ECR #: 2
Title: Buffer V-I Equations
Release Date: Nov. 15, 1996
Impact: Clarification
Spec Version: A.G.P. 1.0

Figure 0-1 V/I Curves for 3.3V Signaling

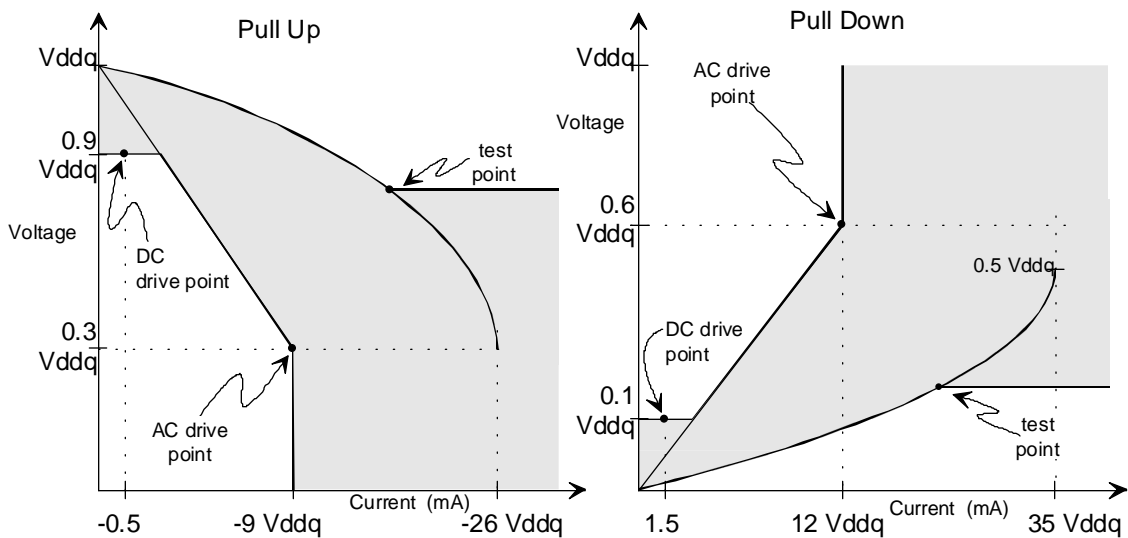
Equations included in figure 4-17 (V-I curves) did not agree with the curves shown in the figure. Also, the usage of these equations was unclear, as the table explaining them (as per PCI spec) was omitted.

Modify the equations to agree with the equations shown on the following page (change the coefficients to 54 and 141, respectively). Also add the attached table to the DC Characteristics section of chapter 4.

The following figure replaces figure 4-17 on page 79 of the rev 1.0 spec:

Equation A:

$$I_{oh} = (54.0/Vddq)*(V_{out}-Vddq)*(V_{out}+0.4Vddq)$$

for $Vddq > V_{out} > 0.7\ Vddq$

Equation B:

$$I_{ol} = (141/Vddq)*V_{out}*(Vddq-V_{out})$$

for $0v < V_{out} < 0.18\ Vddq$
